ADDENDUM NO. 2

February 1, 2019

PROJECT: City Hall Park Improvement Project

FIGURE 3

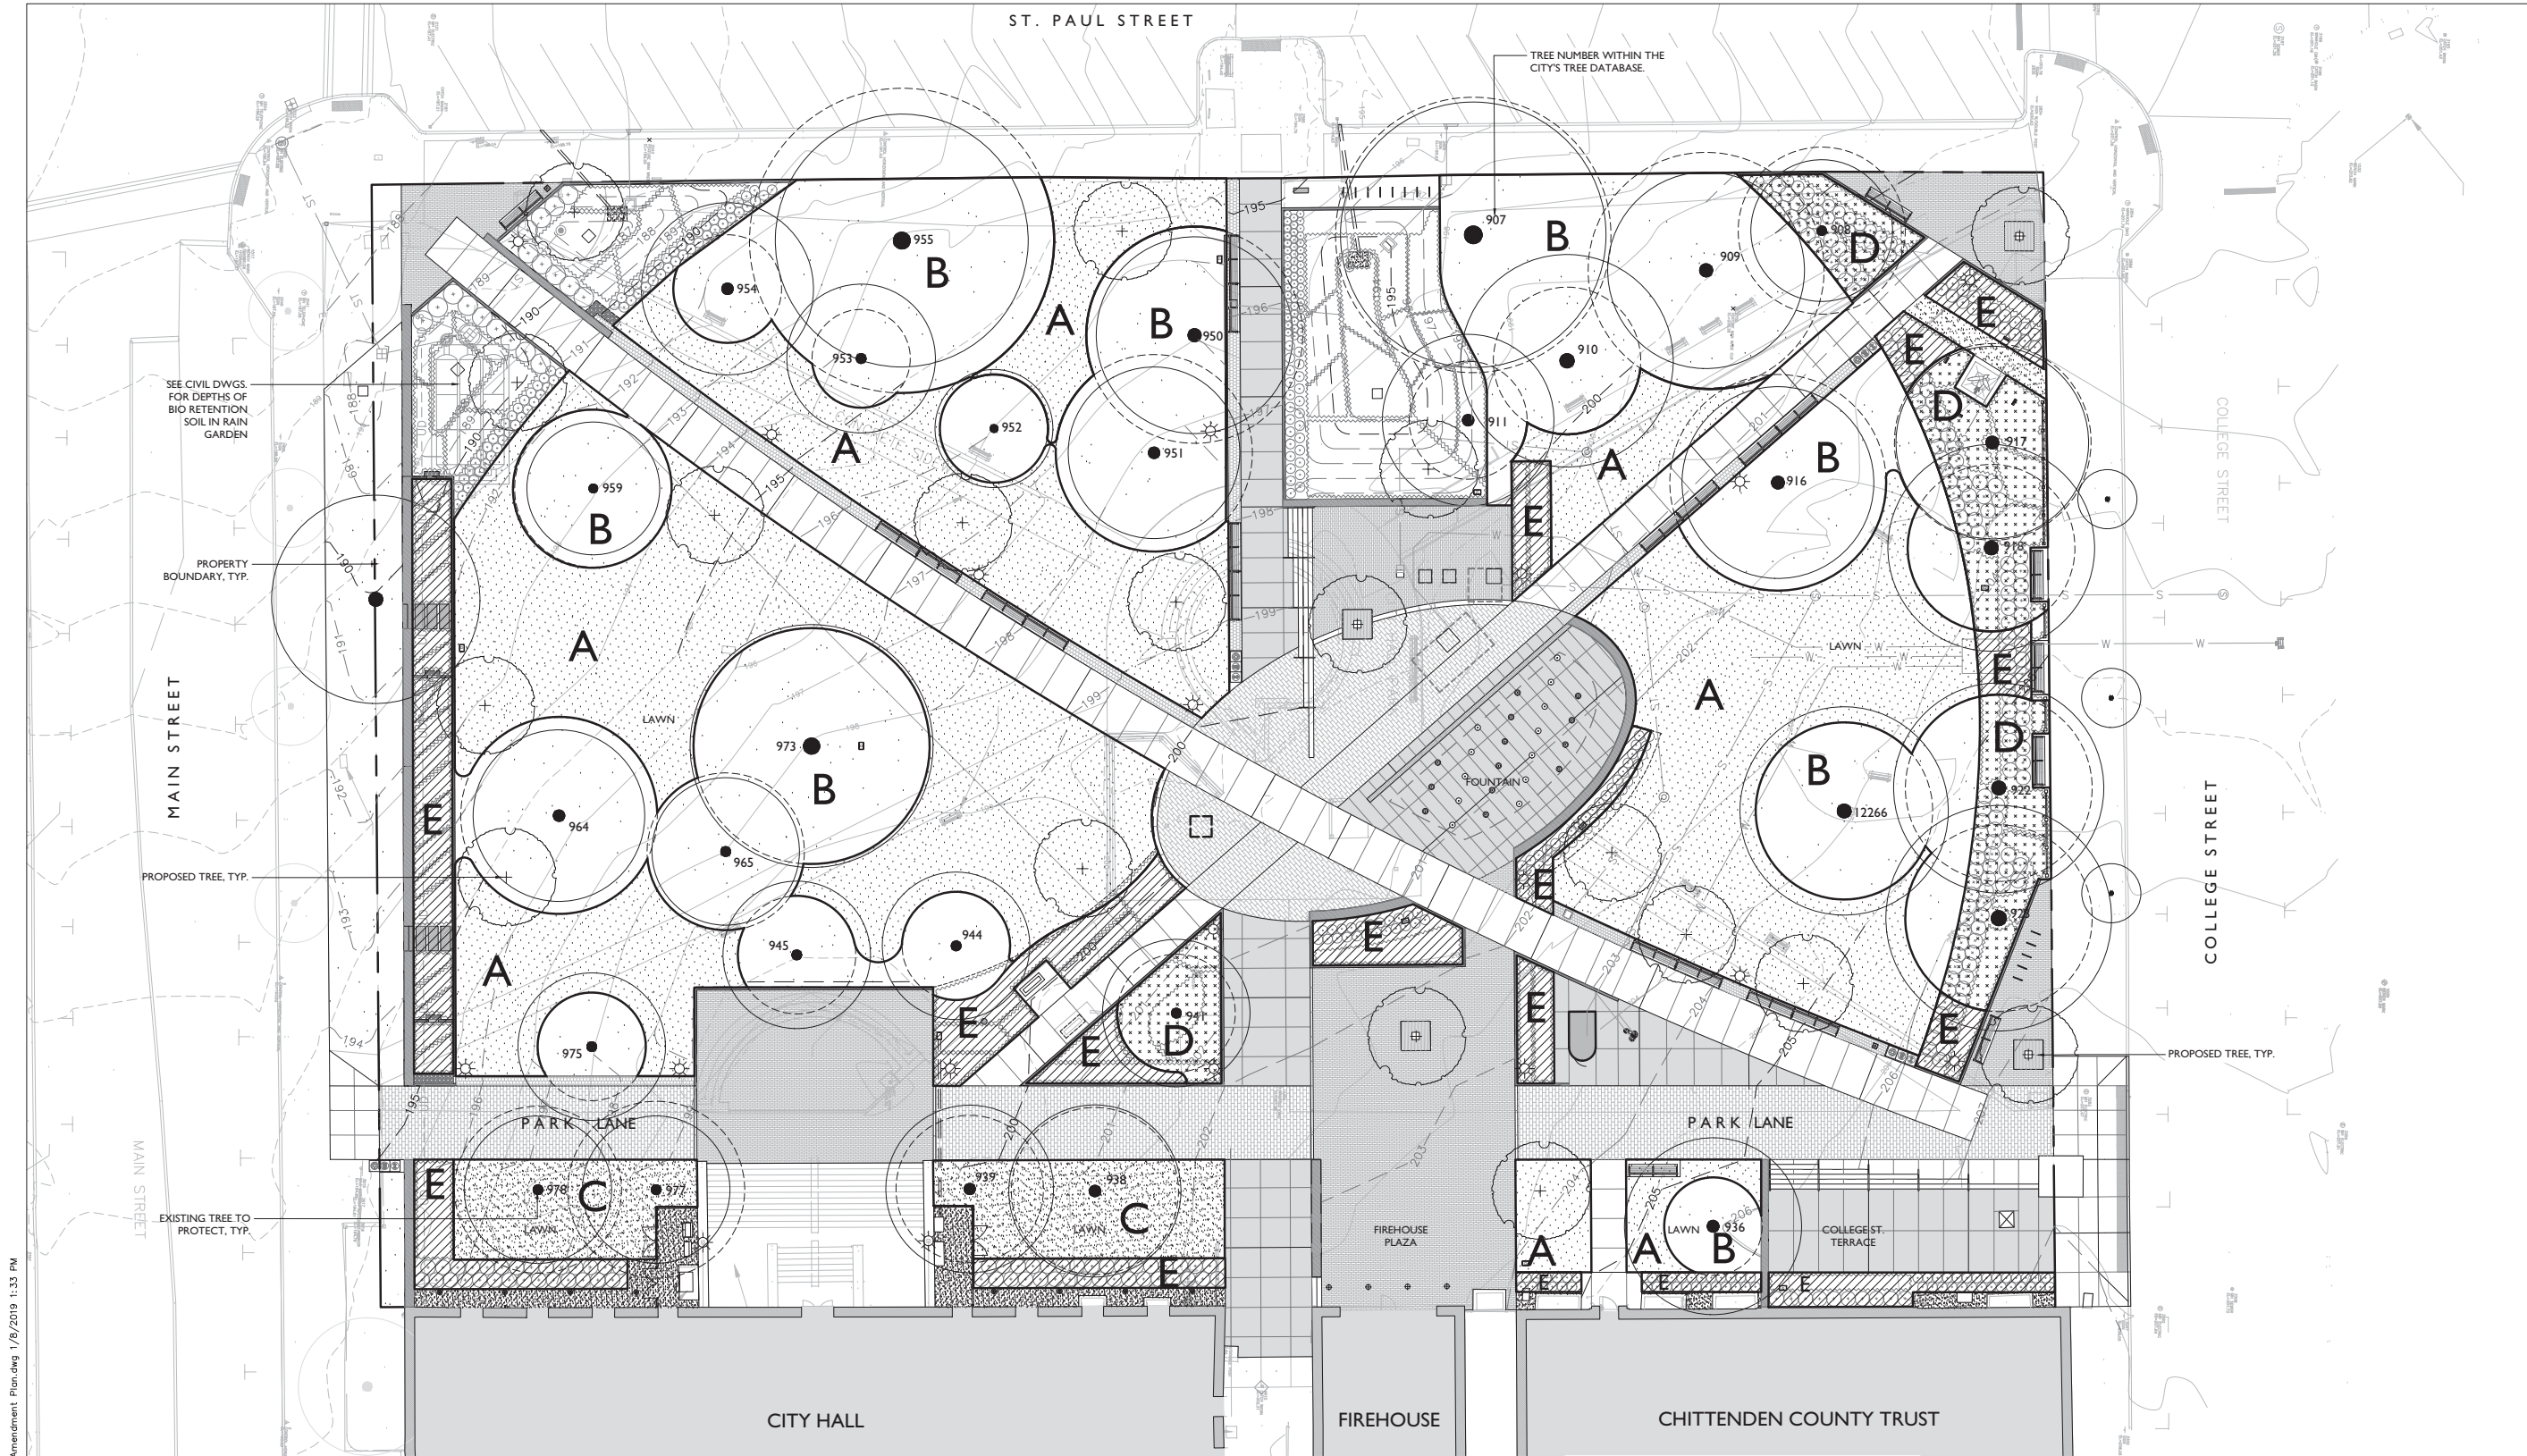
- In areas of the park where there is no excavation necessary and no hardscaping and only grass surface (see Zone “A” in Figure 4), the corrective action will be a combination of use of 6” of clean topsoil and turf development to protect users from dermal contact with PAHs soils. The 6” thickness, necessary to ensure proper drainage and tree health, will require specific approval by the VT DEC as it is a reduction in the thickness (18”) required in the IRULE. Imported topsoil shall be tested for PAHs to ensure it meets SSVs.

- In areas under the drip line of existing trees to be retained (see “B”, “C”, and “D” circles in Figure 4), the existing shallow soil will first be amended through aeration by air spade followed by vacuum extraction of fines followed by amendment with clean topsoil. Additional clean topsoil and seed will be applied under the drip line tapering from 6” at the edge to 0” at the tree trunk, followed by bark mulch in a minimum of 6 ft radius around the trunk. After re-seeding, the area below the drip line will be restricted to foot traffic for a period long enough to ensure proper turf development. This amendment/remedial method can be done in stages (spring and fall) before and after the park renovation process.

C210

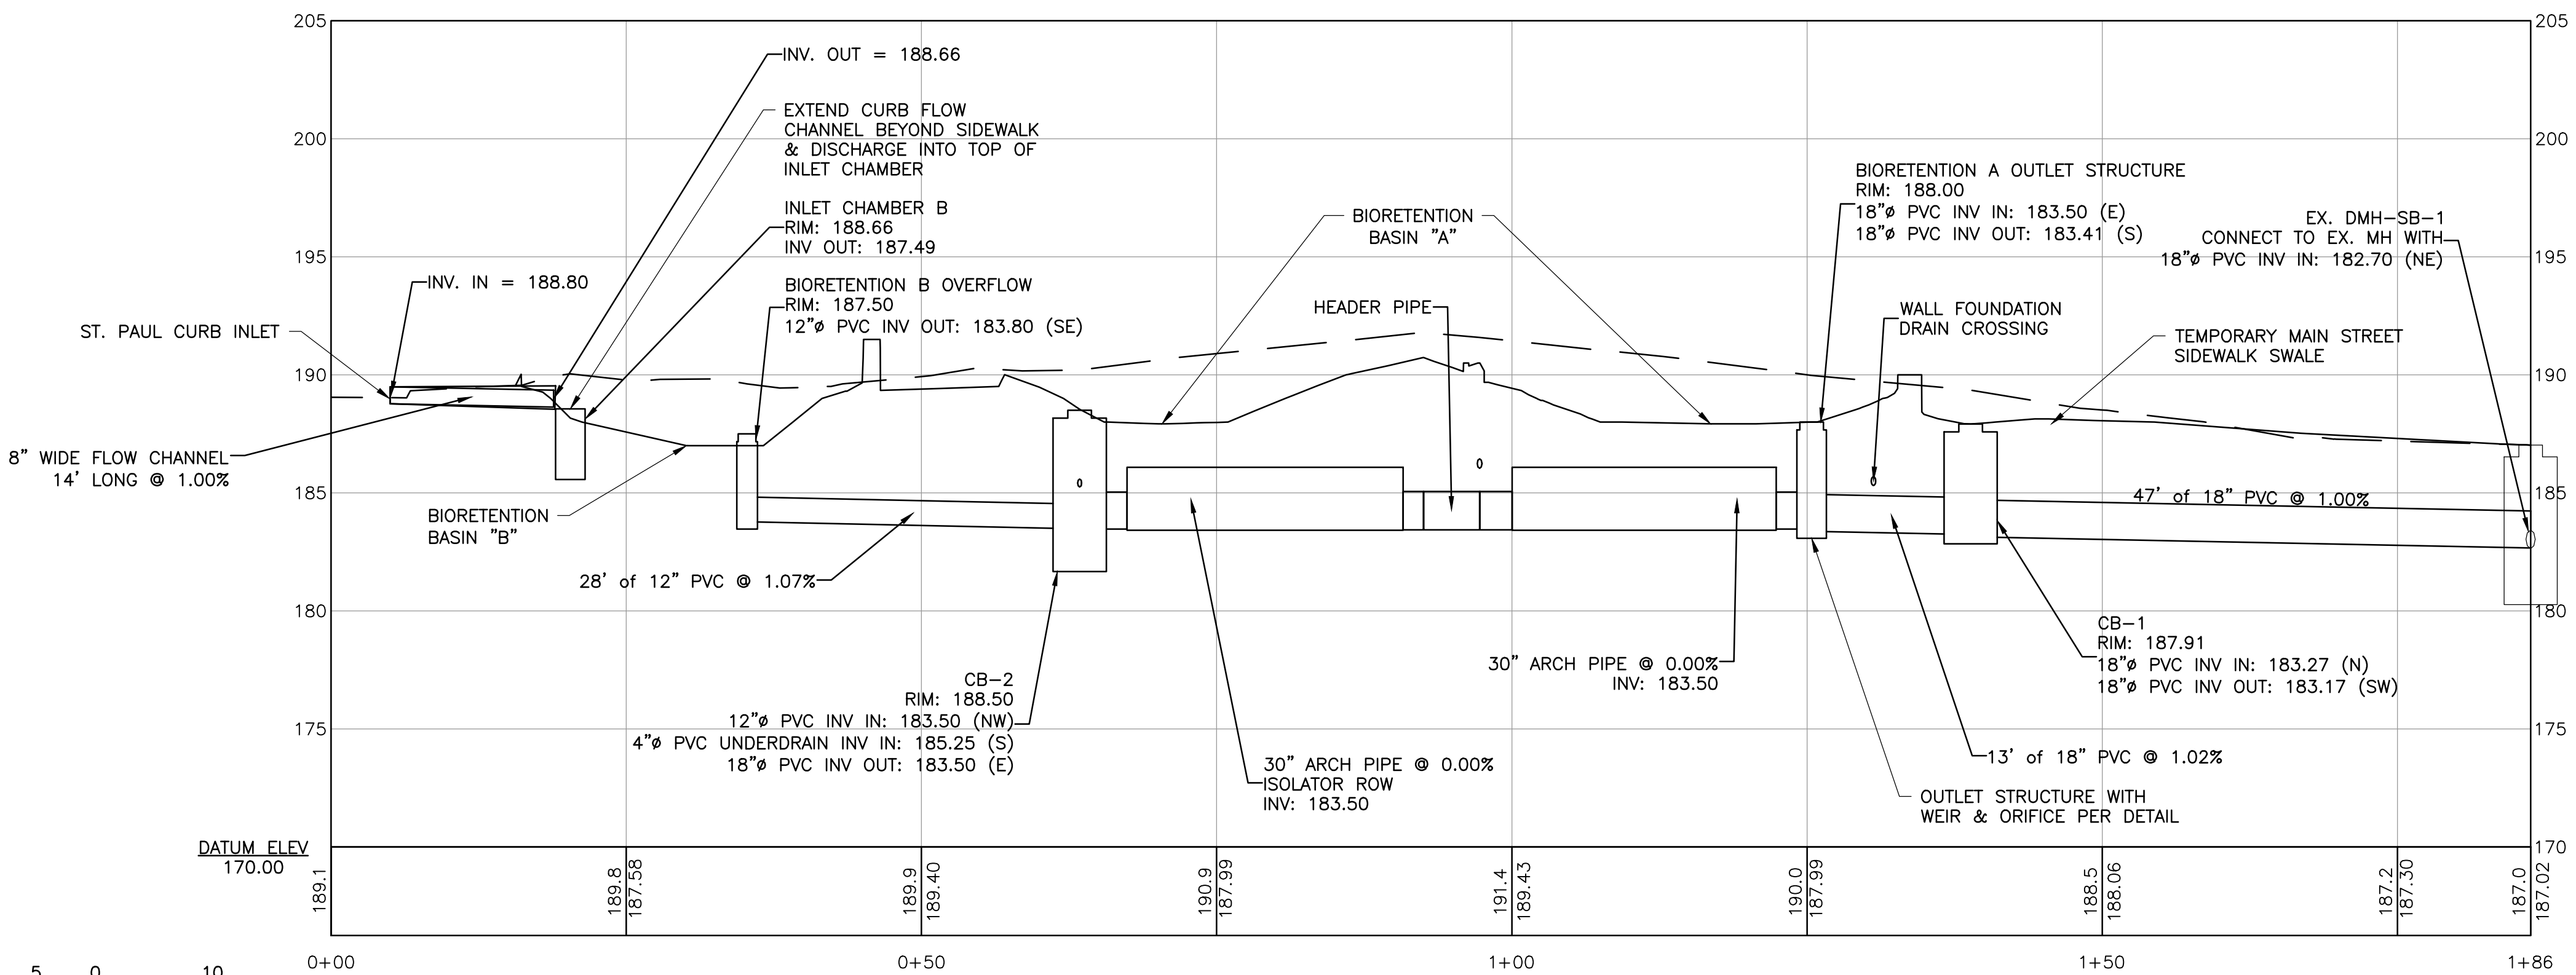
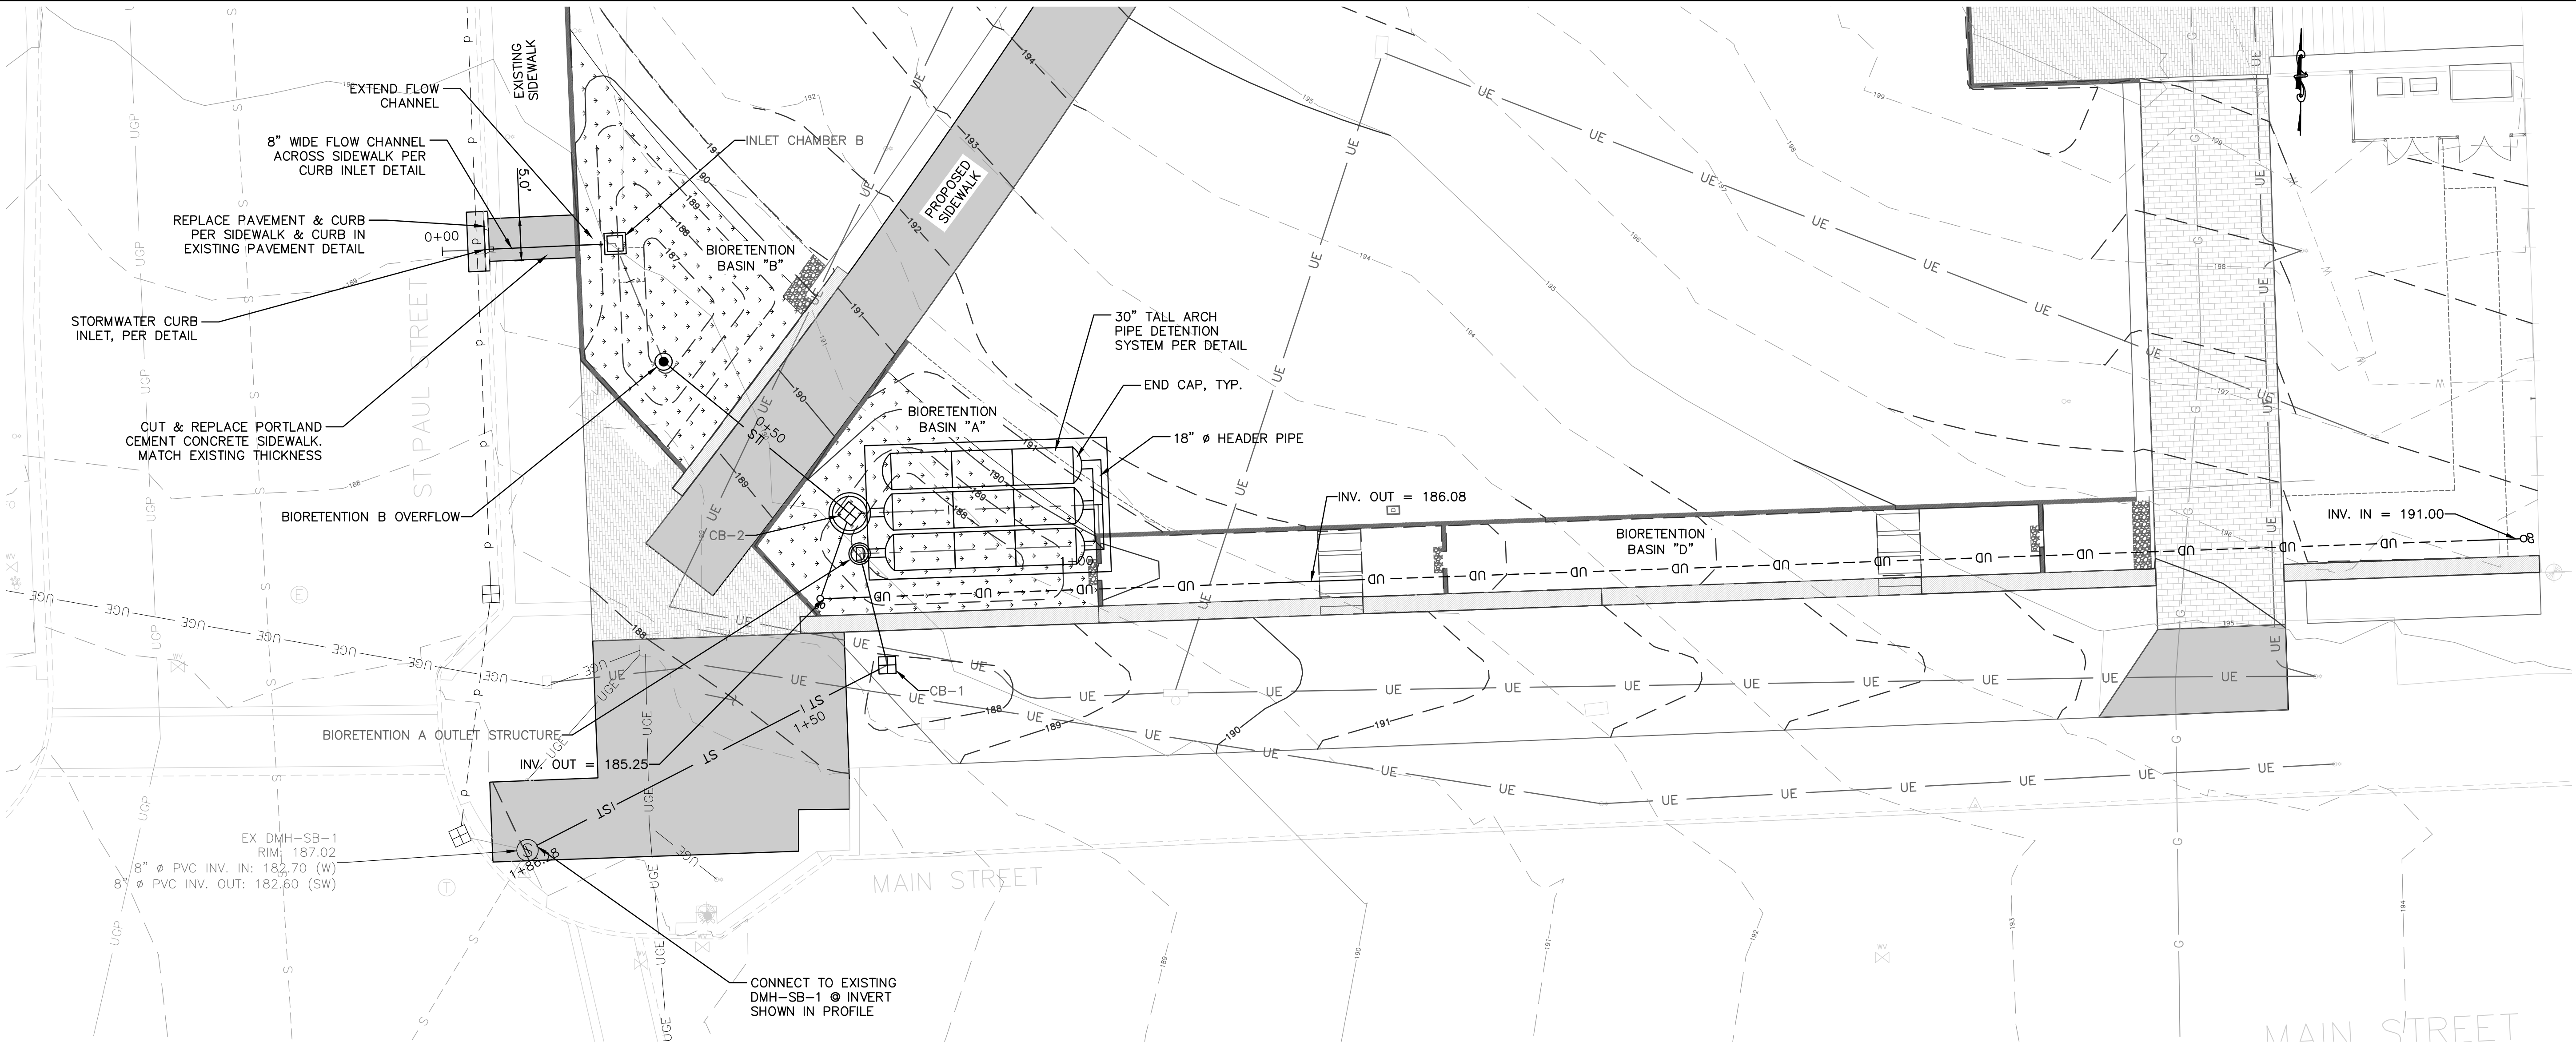
- 1. Sheet C201
 - a. Updated raingarden/bioretenction name labels
- 2. Sheet C509
 - a. Updated Backflow Prevention Vault Details
- 3. Sheet E503
 - a. Updated distribution panel schedules and One-Line Drawing

2. “There is a discrepancy between the Civil Plans and Landscape Plans and how they label Rain Garden ‘A’ and Rain Garden ‘B’. The rain garden labeled ‘A’ on the Planting Plan (starts in the SW corner and runs along Main St) is substantially larger, but on civil plans it is labeled ‘B’. In the addendum to the question about stepping stones through the Rain Garden, the answer indicates the stepping stones are incidental to Rain Garden ‘C’, which has no stepping stones. I’m hoping to have that cleared up.”

RESPONSE: The rain garden labels on Sheet C201 have been modified as follows: Rain Garden B is at the SW corner of the site. Rain Garden A is the rain garden with the arch pipe proposed beneath it. Rain Garden C is the northernmost, mid-block rain garden (not shown on Sheet C201). Rain Garden D is the linear garden which runs behind the Main Street wall and dumps into Rain
